Buttrey Development Four, L.L.C.

**Subject: Figure 4 (revised)
Permit Application Nos. SC48-0165969-008 & SO48-0165969-009**

BUTTREY DEVELOPMENT FOUR
 PROPOSED BASE GRADE ELEVATIONS

BASE GRADE ELEVATIONS BD4 PARCEL	JAN., 2005
SCALE: 1" = 200'	FIGURE 4 (REVISED)

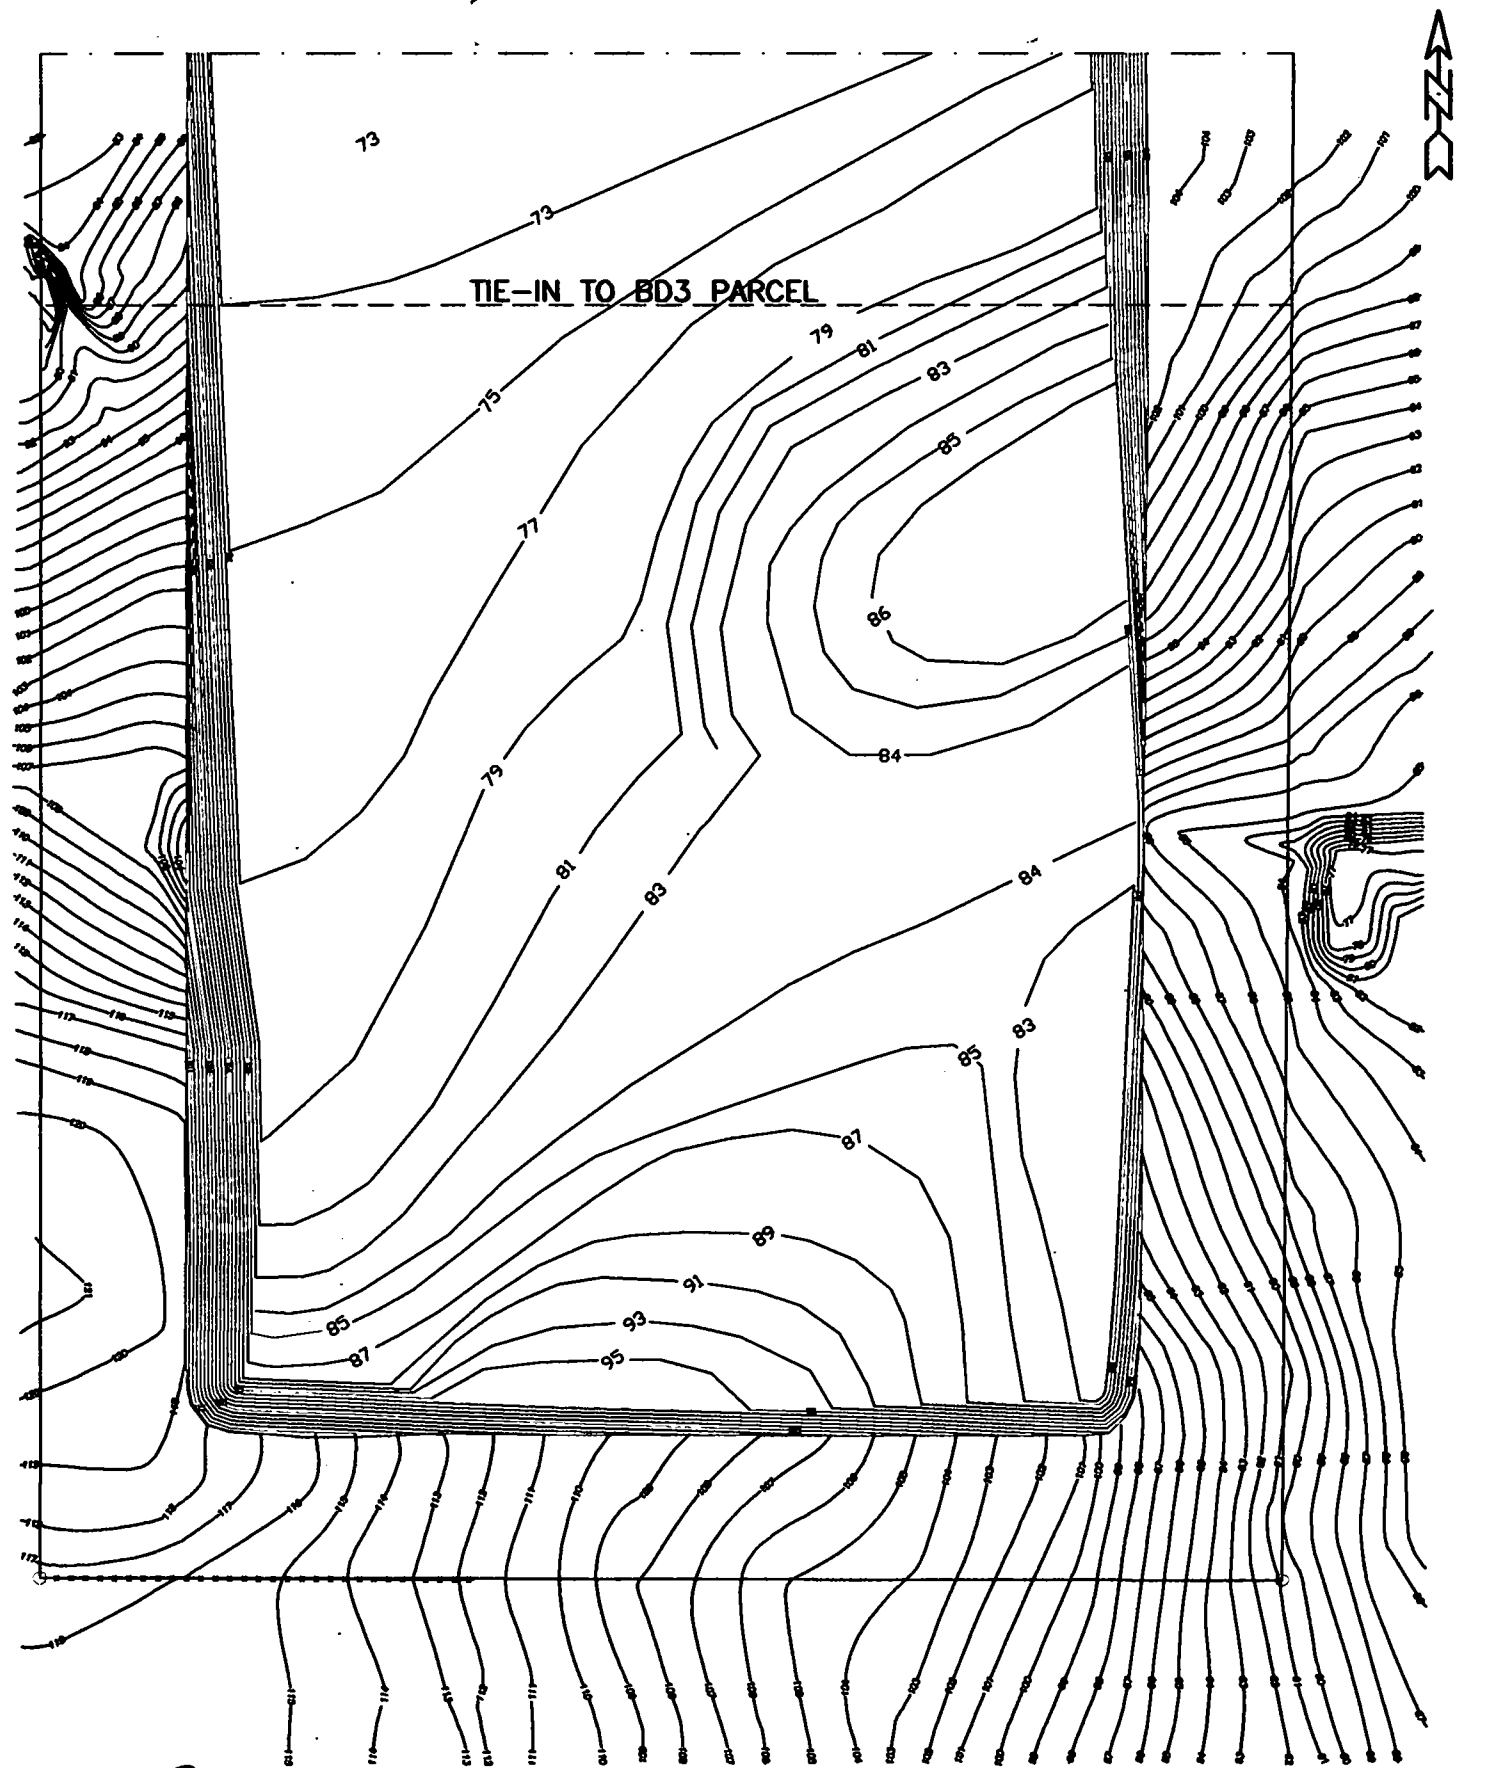
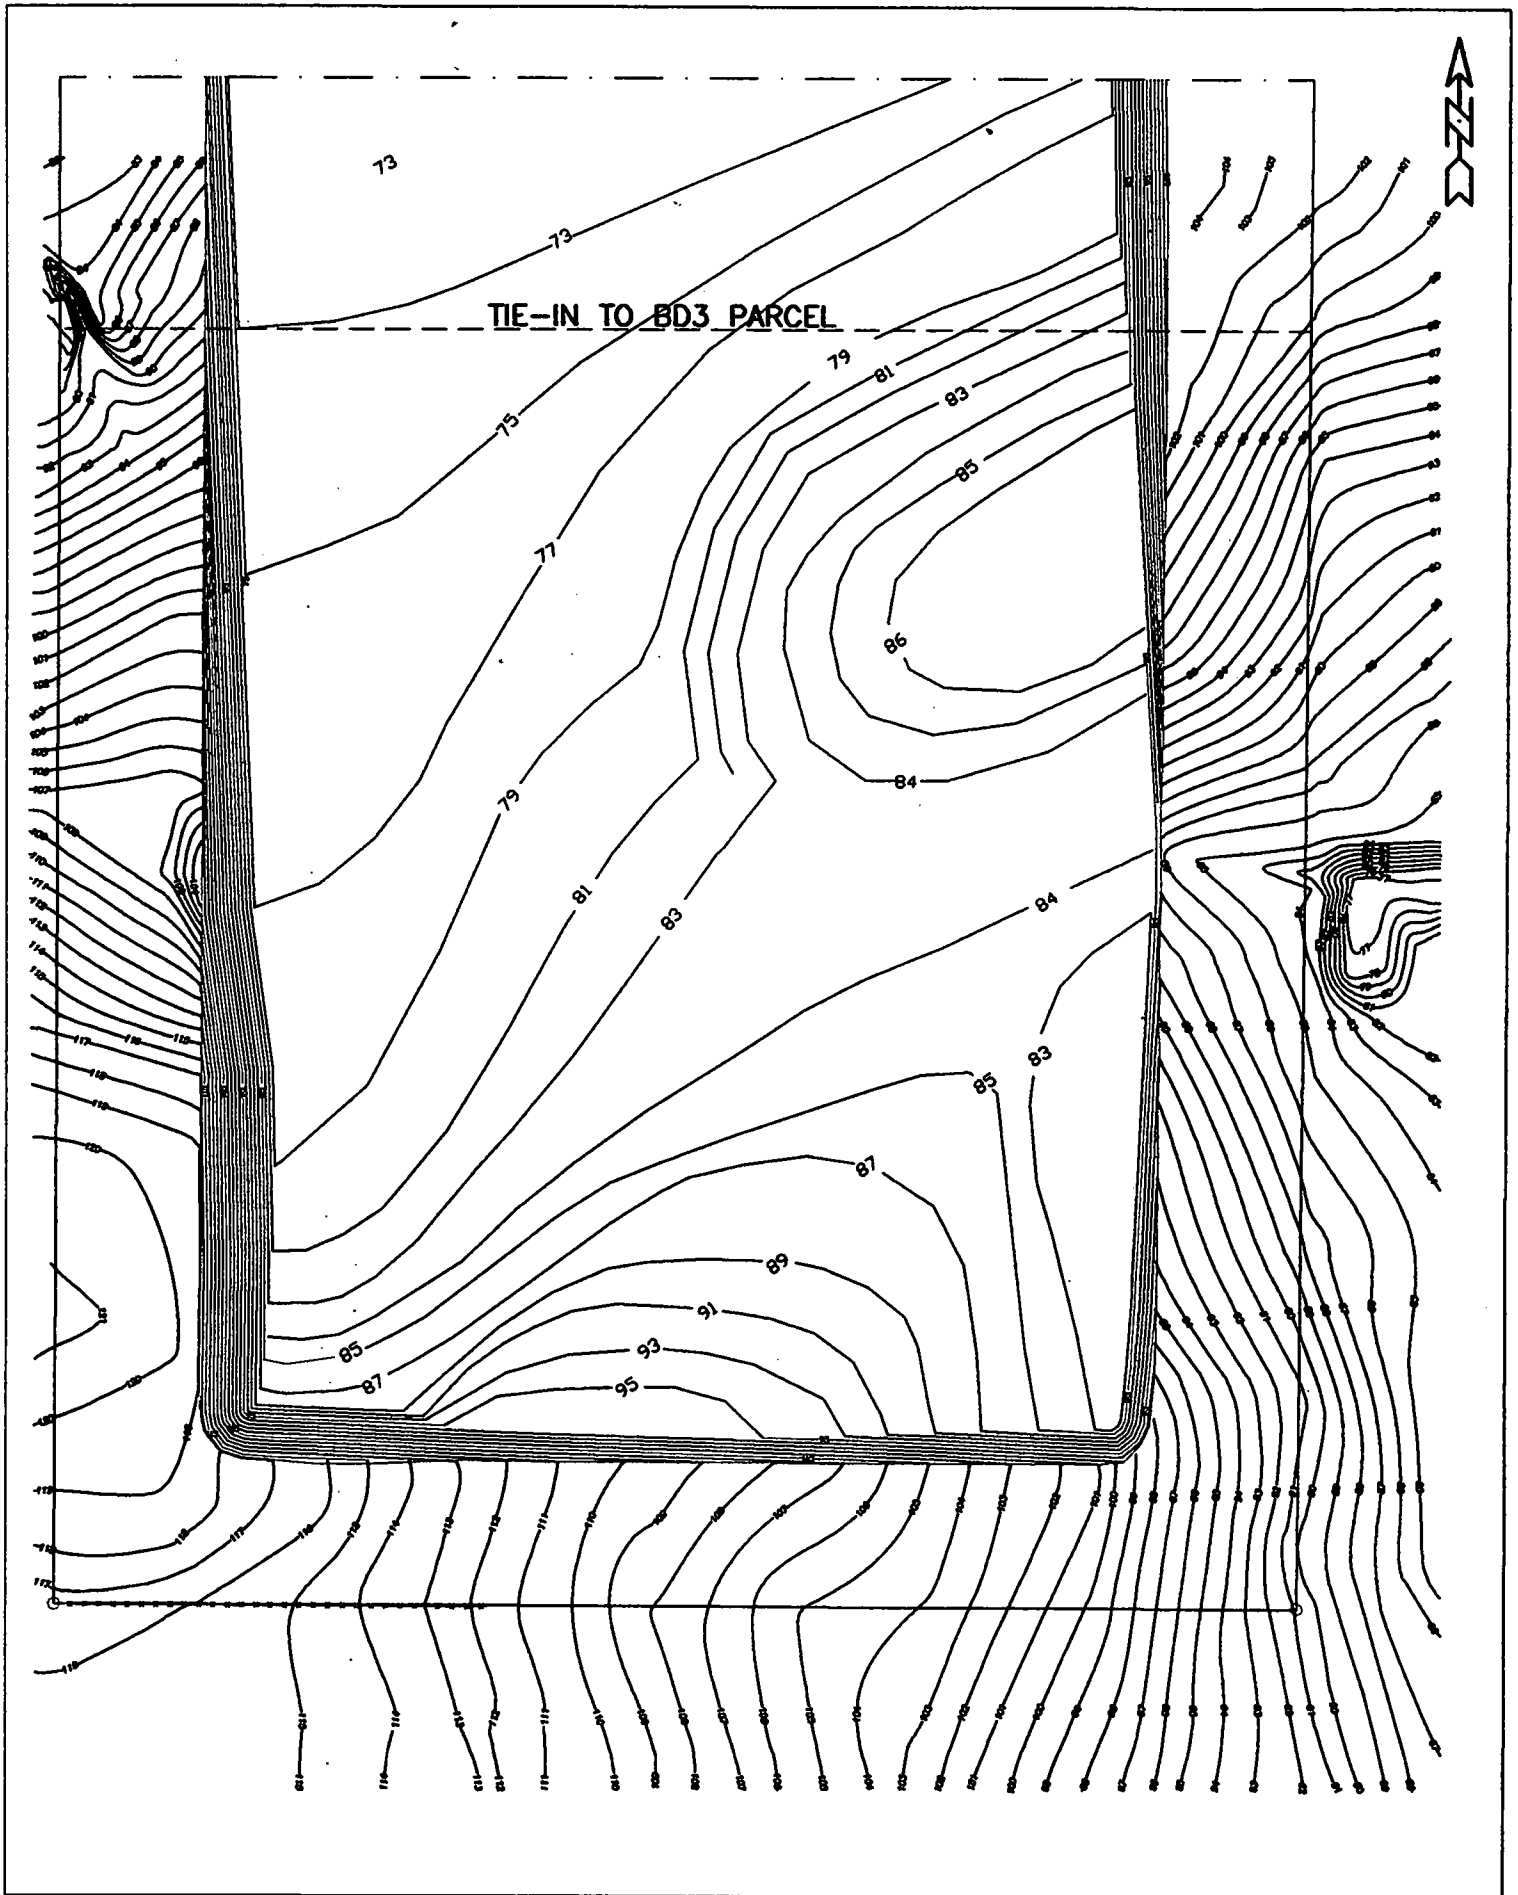
Attached are copies of a revised Figure 4 for the above referenced subject. This is the same Figure 4 submitted to Debra Laisure on February 21, 2005 during her review of the ERP modification for this project. As noted in that ERP correspondence, this Figure 4 (revised) was to be incorporated into the Solid Waste Application.

While I can't verify that I submitted the revised Figure 4 as part of a Solid Waste RAI, it was my intent to do so in order to make the final base grades of the ERP and Solid Waste permits identical.

In addition, please correct specific condition 6 of the draft permit to state that no solid waste will be placed below elevation 75" NGVD on the Buttrey Development Four parcel.
